SACRAMENTO MUNICIPAL UTILITY DISTRICT  
The Power To Do More.™

Docket No. 50-312  
Rancho Seco Nuclear Generating Station  
License No. DPR-54

**RESPONSE TO NRC REQUEST FOR ADDITIONAL INFORMATION**

## Response to RAIs Dated February 27, 2007

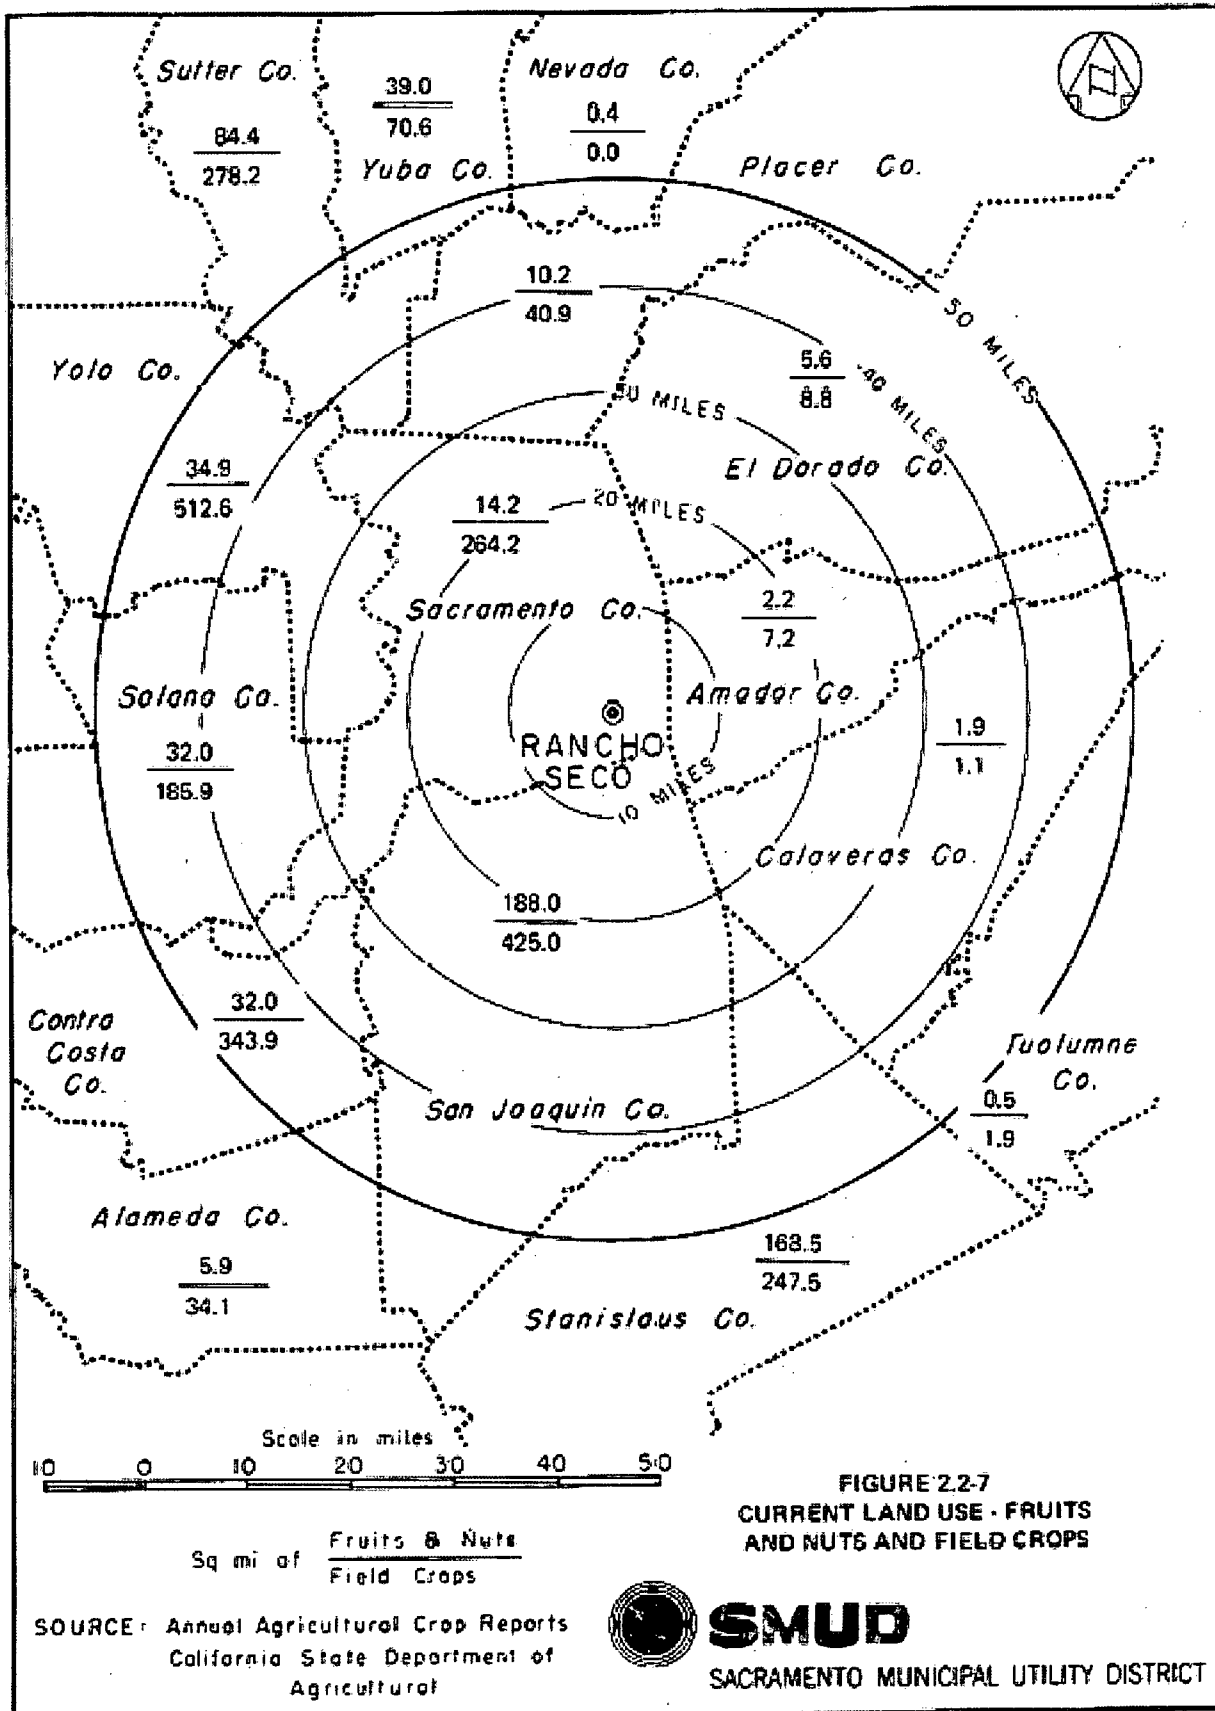
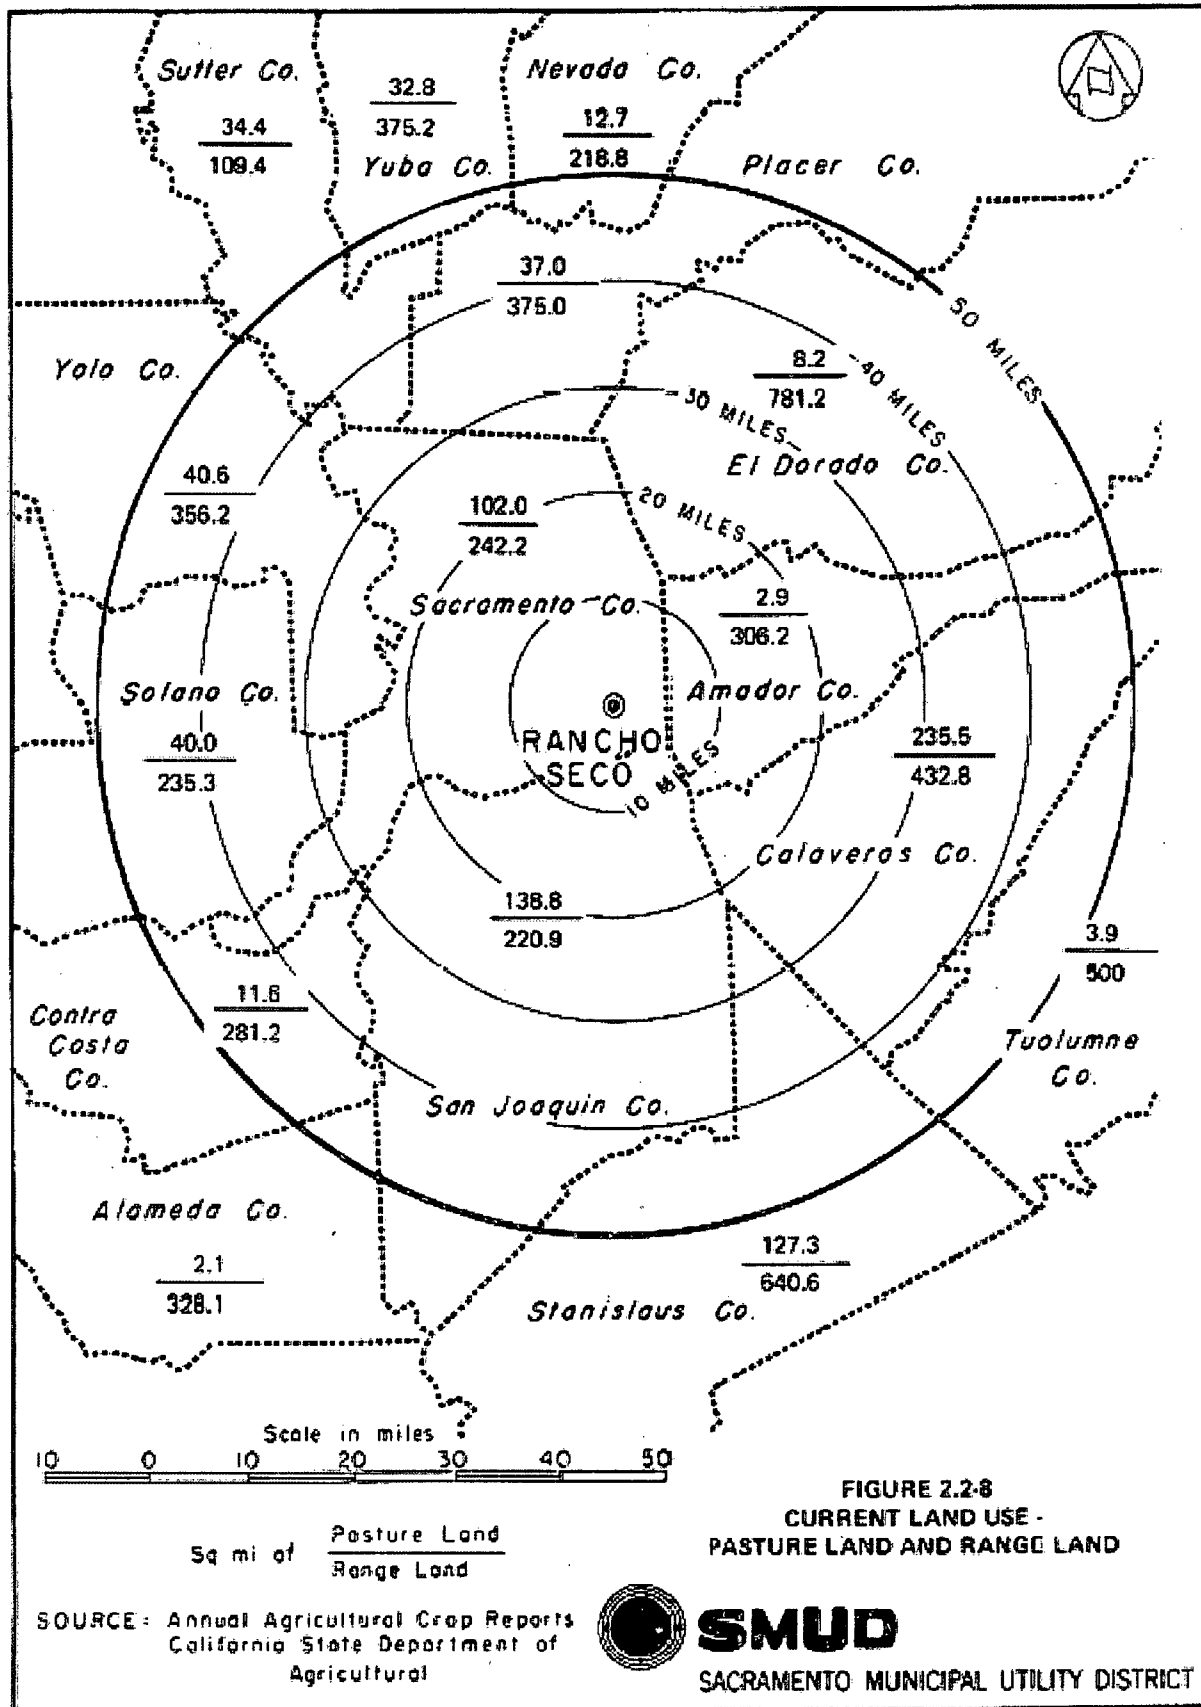
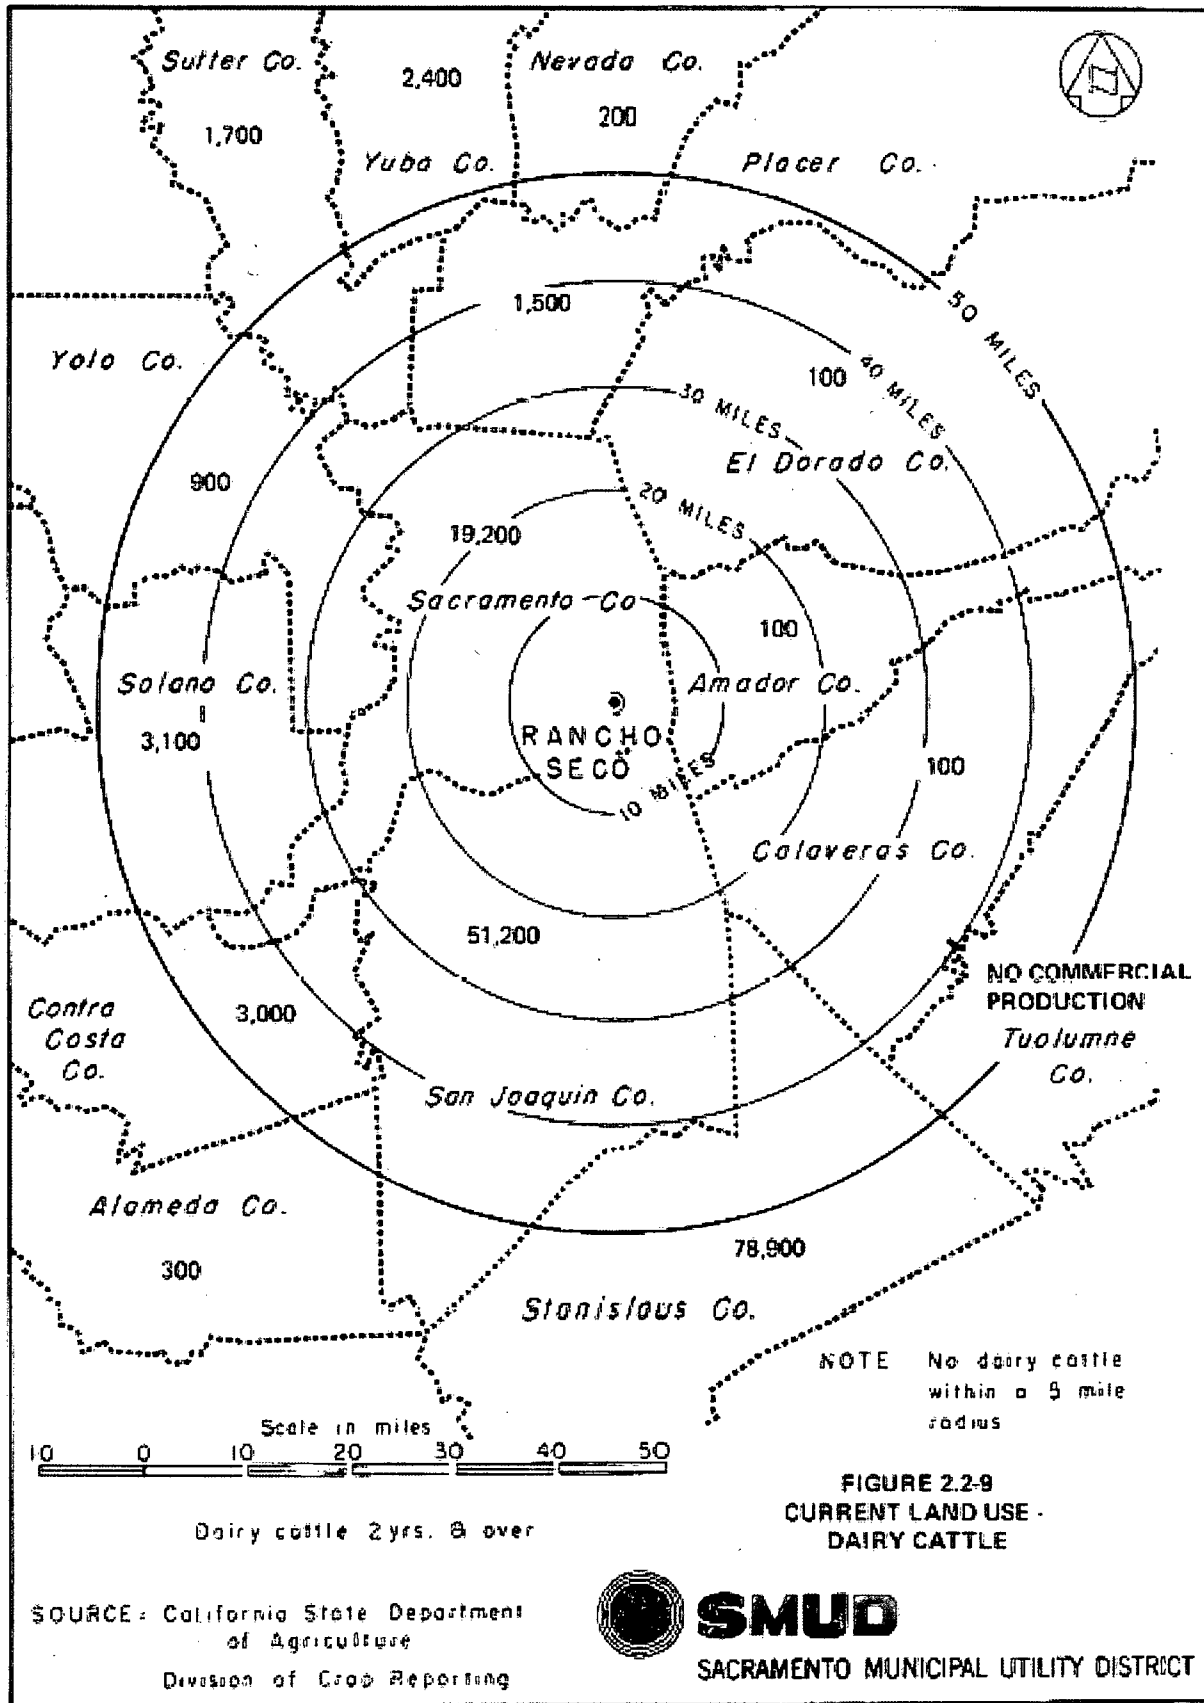
4. Section 8.5.1.3.1, Land Use, states that the Rancho Seco Updated Safety Analysis Report (USAR) Figure 2.2-6 provides a detailed description of all agricultural and residential activities within a 5-mile radius of the site, and USAR Figures 2.2-7, 2.2-8, and 2.2-9 identify agricultural activities within a 50-mile radius.

- a. The Defueled Safety Analysis Report (DSAR), Amendment 2, Section 1.1, Introduction, states that the DSAR replaced the USAR as the primary licensing basis document applicable to Rancho Seco in the Permanently Defueled Mode. Further, Figure 2.2-4 of this document appears to be the only figure in the DSAR that identifies agricultural uses. Given these differences in descriptions between the Supplemental Environmental Report reference to the USAR and the DSAR, please provide new copies of the appropriate figures that identify current agricultural and residential activities to better assure that our review is addressing the applicable information.

- b. Please identify references used for any information provided. Further, please include a brief written explanation of the figures provided.

Attached below are Figures 2.2-7, 2.2-8, and 2.2-9 of the Rancho Seco USAR. These figures represent the agricultural activities within a 50-mile radius of the plant.

Figures 2.2-7, 2.2-8, and 2.2-9 are contained in USAR, Amendment 8.

Figure 2.2-7 shows fruit, nut, and field crops, Figure 2.2-8 shows pastureland and rangeland, and Figure 2.2-9 shows land used for dairy cattle.

**Figure 2-3.**  
**Topography and Surface Water**  
**Features Surrounding RSNGS**

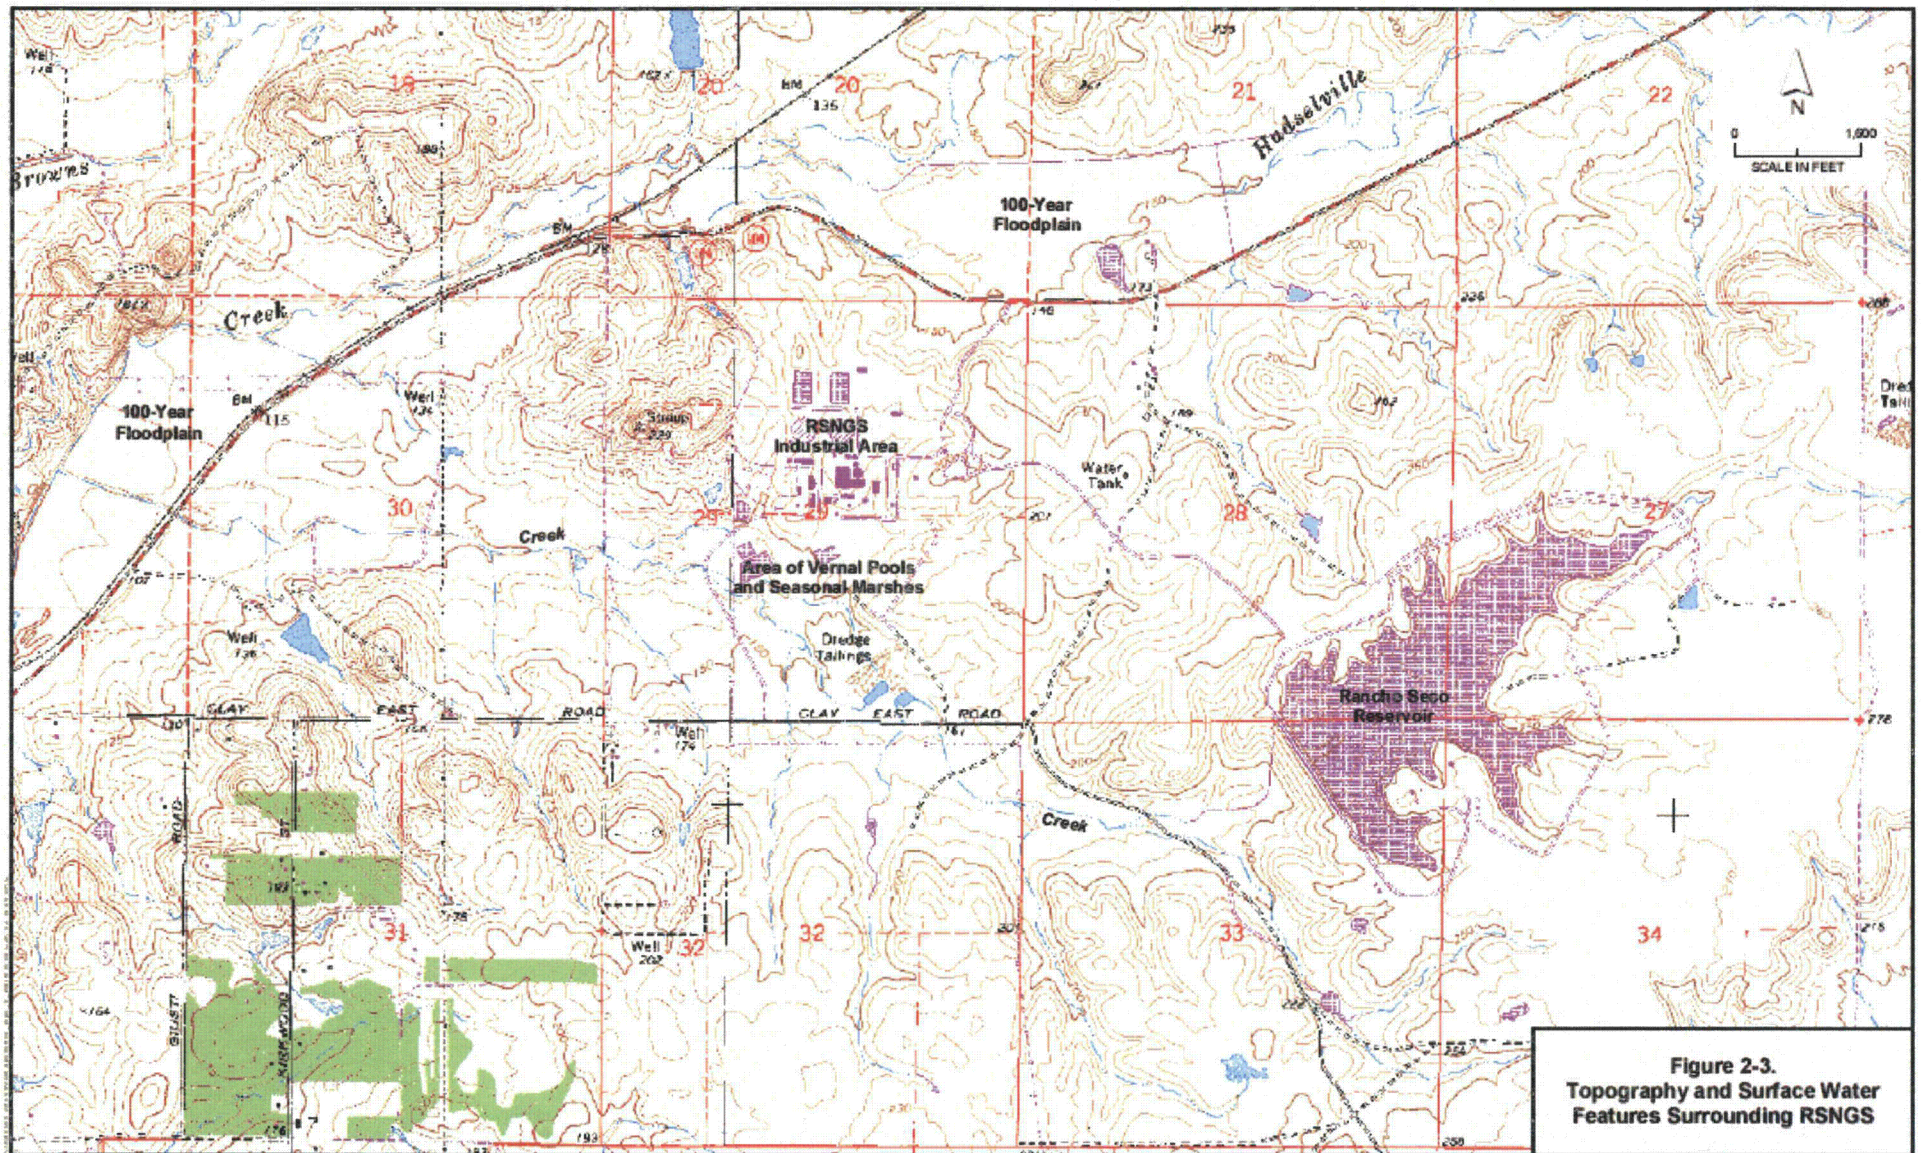
- c. Please identify the location of the nearest flooding outside of the current site boundaries for the same period of years or at least the last 100 years, whichever is the longest period of time.

The answer to this RAI was provided in response to RAI No. 40 contained in the first set of RAIs. Creeks, streams, rivers and other surface water drainage features along with flood elevations are shown on Figures 2-2 and 2-3 in the Hydrogeological Characterization Report. 100-year flood plain maps for the immediate areas surrounding the Rancho Seco site are shown on Figure 2-3. General 100-year flood area information for Sacramento County may be viewed at <http://www.msa.saccounty.net/waterresources/floodready/FloodMap.pdf>. Figure 2-3 from the Hydrogeological Characterization Report is provided on the next page followed by a portion of the map located at the referenced url, which shows the 100-year flood plain near the Rancho Seco site location without contour lines. As shown on the two maps, the nearest 100-year flood plain outside of the current site boundaries results from Hadseville Creek north of Twin Cities Road (Hwy 104) across from the main entrance to the site.
